Technical Bulletin TB247
11.2024

Description: Instrument Connectivity System Menu Trays

Model Affected: Speed Twin 900 from VIN CC4121 to VIN TBC, Speed Twin 1200 from VIN CB9662 to VIN TBC, Speed Twin 1200 RS from VIN CB9979 to VIN TBC

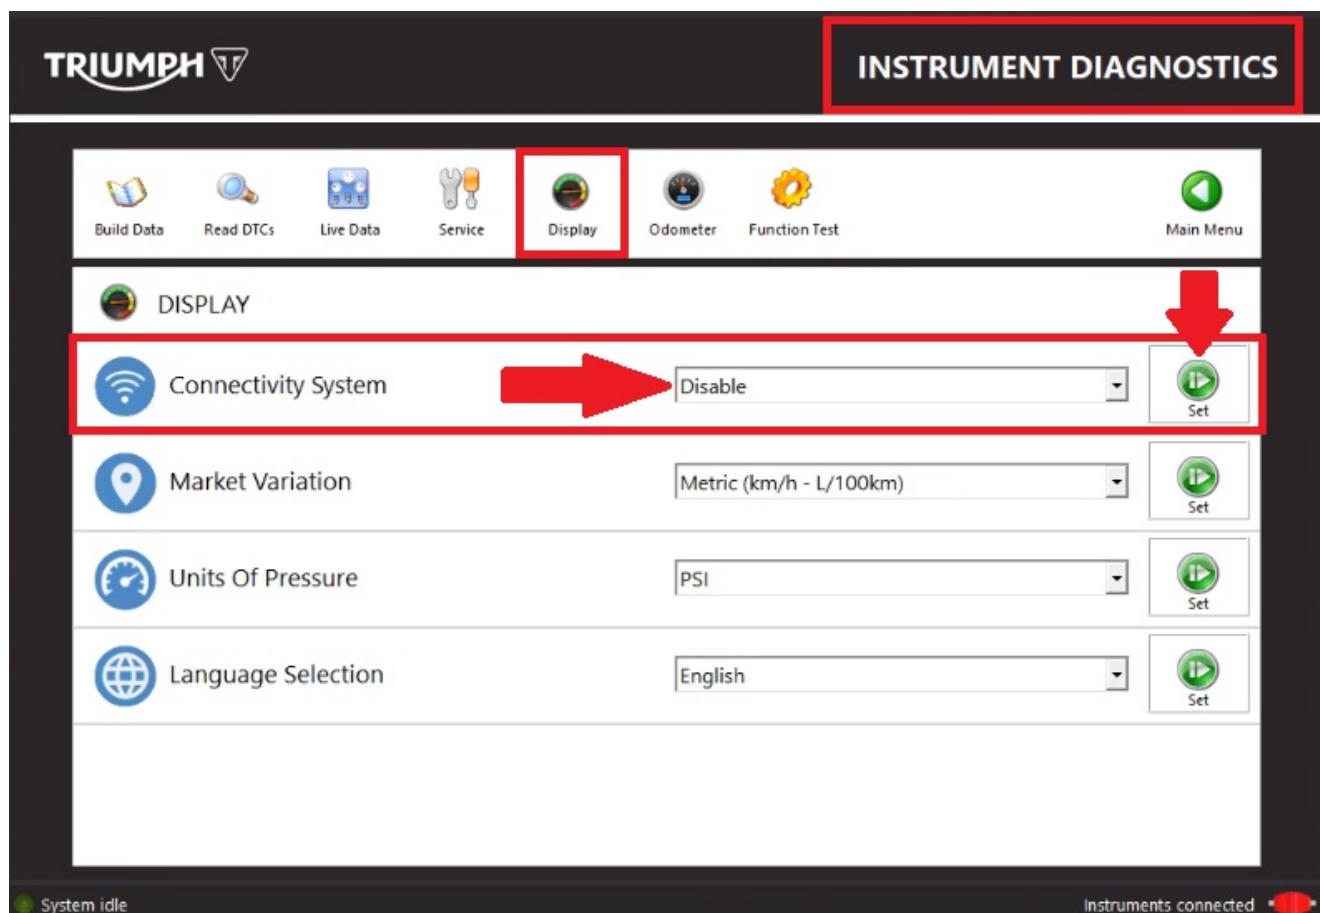
We would like to inform dealers that models in the VIN ranges specified above will be delivered with instrument connectivity menu trays incorrectly enabled.

The My Triumph Connectivity Module is available as an optional accessory on the above models and is not fitted as standard.

Dealers are requested to adjust the Instrument Connectivity System Status as follows when performing pre-delivery inspections on the above models.

1. Connect the Triumph Diagnostic Tool.
2. Update and unlock the motorcycle as per the normal Pre Delivery Inspection process.
3. From the home screen, navigate to **Diagnostics -> Instruments -> Display**.
4. Select "Disable" from the drop-down box next to the "Connectivity System" label.
5. Click "Set" and wait for the process to complete.

6. Validate the process has completed by cycling through the instrument menus. Connectivity menu trays should no longer be visible.
